REMARKS

Serial No.: 09/935,926
September 13, 2002

6/8

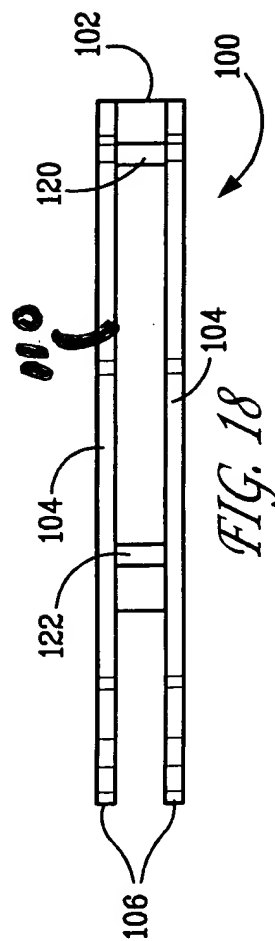
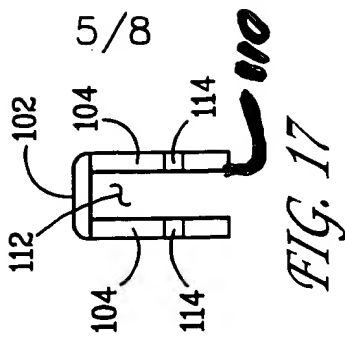
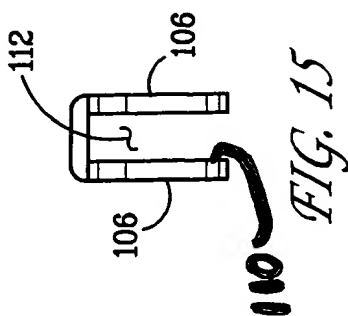
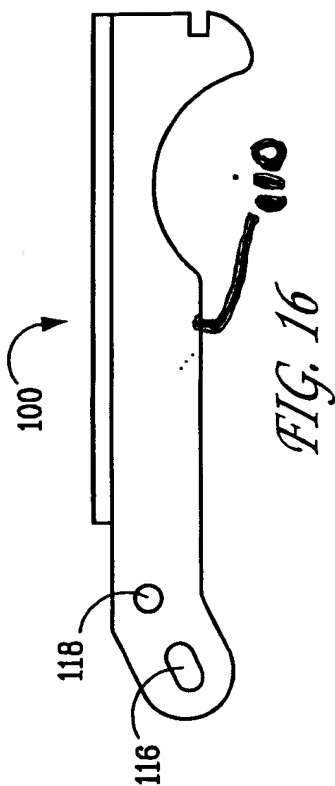
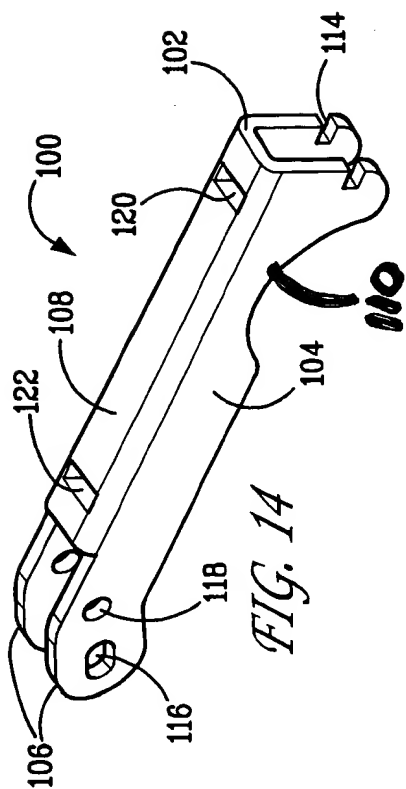
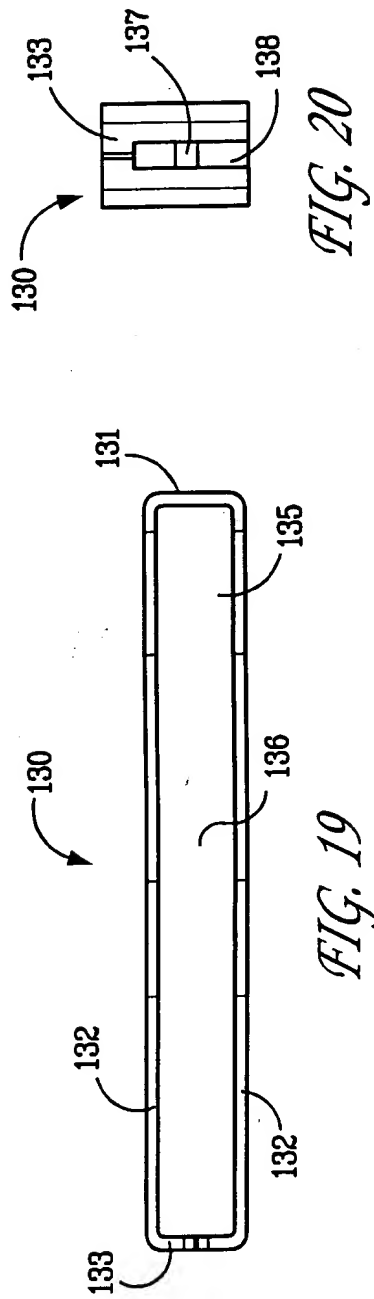
The drawings stand objected to as failing to comply with 37 C.F.R. 1.84(p)(4) because the reference character "220" had been used to designate both snap legs and frame. A proposed drawing correction is enclosed herewith for the Examiner's review and approval. Reconsideration and withdrawal of the drawing objection are respectfully requested.

The drawings stand objected to as failing to comply with 37 C.F.R. 1.84(p)(5) because they do not include the following reference numerals mentioned in the description: 30 on page 4, line 35; "200" on page 5, line 22, "216" on page 5, line 25, "110" on page 7, line 5 and "149" on page 8, line 17.

Proposed drawing corrections are enclosed herewith for the Examiner's review and approval. The suggested addition of reference numerals is provided in red on the drawing

sheets (Sheets 1/8, 5/8, 6/8 and 7/8). Reconsideration and withdrawal of these further drawing objections are respectfully requested for this reason.
